Paco Pumps, Inc.
Onsite

9201 San Leandro St, Oakland, CA

LOCATION OF ISSUES DISCUSSED

Paco Pumps, Oakland: Issues Raised by County March 7, 2014
 Agenda for Discussions at Meeting Scheduled for April 22, 2014

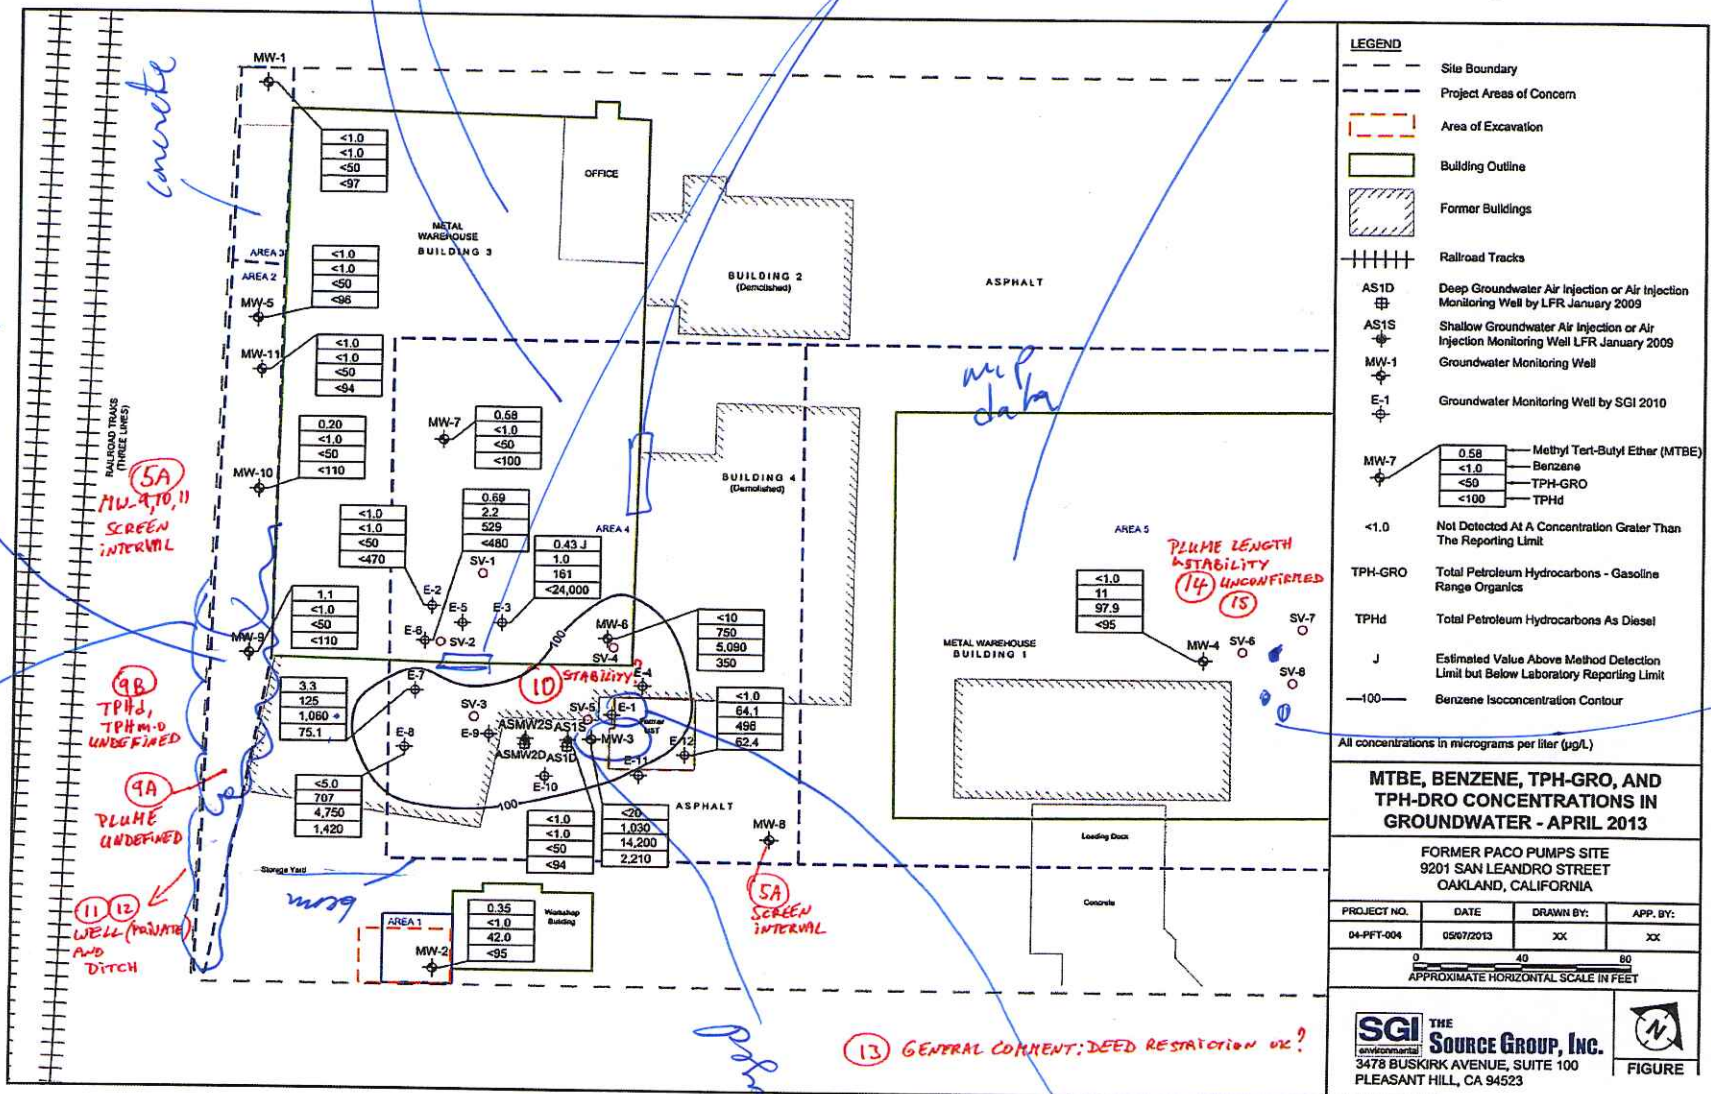
(5A) MW-9, 10, 11 SCREEN INTERVAL

(9B) TPHd, TPH-GRO UNDEFINED

(9A) PLUME UNDEFINED

(11) (12) WELL (PAINA) AND DITCH

(10) STABILITY

(13) GENERAL COMMENT: DEED RESTORATION OK?

PLUME LENGTH STABILITY (14) UNCONFIRMED (15)

Figure 3
SUMMARY OF COUNTY
RISK CONCERNS

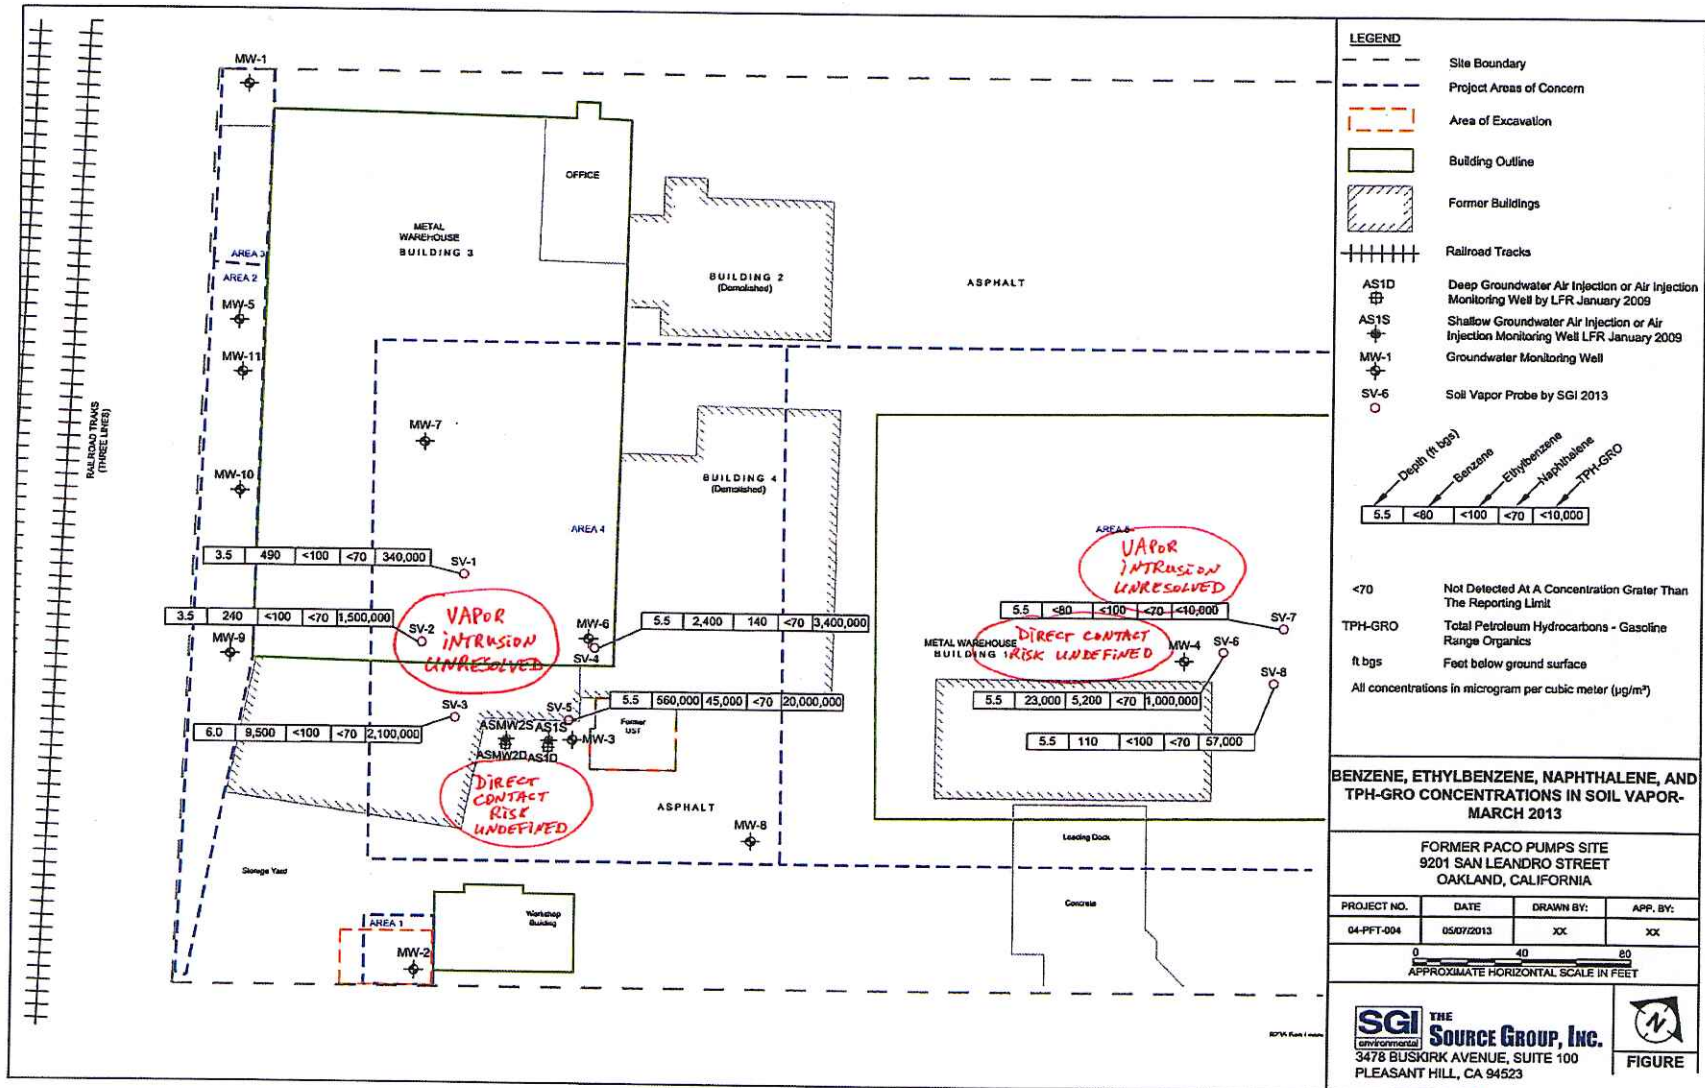
SGI Reference	County Concerns:	SGI Response	SGI Recommendation	Attachment
1	1 Area 1 PCBs present in Area 1?	Samples from 2009 excavation were not sampled for PCBs. 2008 Workplan for that excavation and sampling did not propose PCB testing, and Dec 10, 2008 County approval did not request PCB testing see also comments on Area 2 PCBs	No Further Action	Attachment 1
2 & 4	1 Area 2 Potential PCBs in Area 2?	Previous (2008) report indicates that the PCBs are likely due to leaky transformer north of the site. 18 soil samples in Area 2 were tested for PCBs, with 13 non-detected and 5 samples with detected PCB concentrations from ND to <0.74 mg/kg (Current USEPA RSL, Industrial site). 2008 LFR Workplan proposes no action. County agreed Dec 2008. One historic sample at 5 ft depth (B-7) with 530 ppm TPHmo had PCBs at 0.29mg/kg. Recent soil contained up to 8,800 mg/kg TPHmo. One Pit 3 sample at 3 ft: 14 ppm As-no other data from 1987, but 3 samples in that alley in 1992: B 8, B9 and B10 at 1 ft: ND arsenic.	Potential Data Gap: sample high TPHmo shallow soil for PCBs e.g. at MW-10 2.5 ft (8,800 TPH mo) and MW-11 2.5 ft (2,100 TPH mo)	Attachments 2, 3 and 1

3	1 Area 2 Arsenic in Area 2?	See Comment 2 PCBs attributed to off-site transformer	Not a significant issue. Add As analysis to the Issue 2 samples	Attachment 4
4	1 Area 3 low PCBs?- See Comment 2	See Comment 2 PCBs attributed to off-site transformer	See Comment 2	Attachment 5, 1
Areas of Concern	Areas 1, 2, 3 Separate Areas 1, 2, 3 into distinct Area of Concern, separate case	Unnecessary: County approved previous workplans proposing focus on Areas 4 and 5.	Maintain one case under County oversight	
5A	2 Area 4 LNAPL present?	This site has a very high density of wells compared to typical UST sites: extraction wells are 10-30 ft apart. None have recorded LNAPL, multiple gauging events.	LNAPL should not be a concern	Attachment 6
5B	2 Area 4 MW 8, 9, 10, 11 - screen interval starting at 10-12 ft, water found at 8 ft.	The lithology encountered indicates a confined first groundwater, with dry clay extending to the depth to first water (10-12 ft), and water levels rising in the well after installation. In any case, the downgradient wells have no detectable Benzene, TPHg or TPHd. If LNAPL were present, the samples would contain dissolved hydrocarbons.	No Further Action	Attachment 7

6	3 CSM General comment: CSM insufficient	Data Gaps Workplan will address data gaps to update CSM.	Data Gaps/Workplan/CSM Document to be prepared	
7	4 Area 4 Source removal incomplete?	According to ERAS 2008 & Jonas 1992, the suspected UST area has been thoroughly excavated, & the former site has been backfilled. No tank was found. It is clear that some soil excavation in the area known to be contaminated did occur, likely removing a significant mass of contamination (250 cb yds).	Further attempts to drill or geophysically search to determine if a UST was removed or if a waste oil tank may be present are not likely to be effective. Add note to the deed to check for UST upon building removal.	
8	4 Area 5 Source removal incomplete?	Reports point to the absence of a UST. Issue of potential UST may be unresolvable until building is removed. Multiple samples downgradient indicate no significant downgradient groundwater migration. One single soil gas probe with benzene>CHHSL.	Recommend deed restriction that further excavation under that building may encounter soil with hydrocarbons- no further immediate work	Attachment 8

9A	5 Area 4-a Groundwater contamination to southwest undefined	As shown in rose diagram of previous gradient directions, historical data indicate groundwater gradient to the northwest, and downgradient wells in that direction are ND.	Benzene plume is small and groundwater gradient historically points to the location of the new wells. Conduct one year of quarterly groundwater monitoring with silica gel, then request closure with deed restriction for potential hydrocarbons in future excavations.	
9B	5 Area 4-a TPHd, TPH mo Not evaluated	Not significant, but future rounds of sampling will be conducted with silica gel		
10	5 Area 4-b Plume stability not demonstrated	Collect additional data including silica gel testing		
11	5 Area 4-c Private well 620 ft to the southwest	Noted: CSM will be updated		
12	5 Area 4-d unlined ditch 360 ft to the southwest	Noted: CSM will be updated		
13	5 Area 4-e general comment: is deed restriction applicable?	Deed Restriction is applicable

14	5 Area 5-a Area 5 Plume length at unknown source incomplete (see #8)	Presence of a UST is unresolvable until building removed?	Recommend one year (4 quarters) of monitoring and deed restriction that excavation under that building look for UST and hydrocarbons- no further immediate work	
15	5 Area 5-b Plume stability at unknown source incomplete (see #8)	See above		
Vapor Intrusion, Area 4	6 Area 4 Bioattenuation Zone too thin	Under the building, only the southeastern well (MW-6) at the corner of the building has concentrations above the bioattenuation criteria (1,000 and 100 ug/L)- very localized concern.	Any further soil gas testing may lead to sub-slab sampling and to indoor air testing. SGI recommends evaluating current warehouse forklift and propane usage operations prior to additional vapor intrusion related testing.	Attachment 7
Vapor Intrusion, Area 4	6 Area 4 Some TPH in shallow soil	All shallow soil at mid depth 0-5 ft (2.5 or 3 ft depths) under buildings had non-detectable benzene, the compound critical for Vapor Intrusion. Some locations had TPH, but the location with highest TPH (SV-1) had no detectable benzene at any depth.	No further shallow soil sampling recommended unless a source within the footprint of the building is identified.	Attachment 9
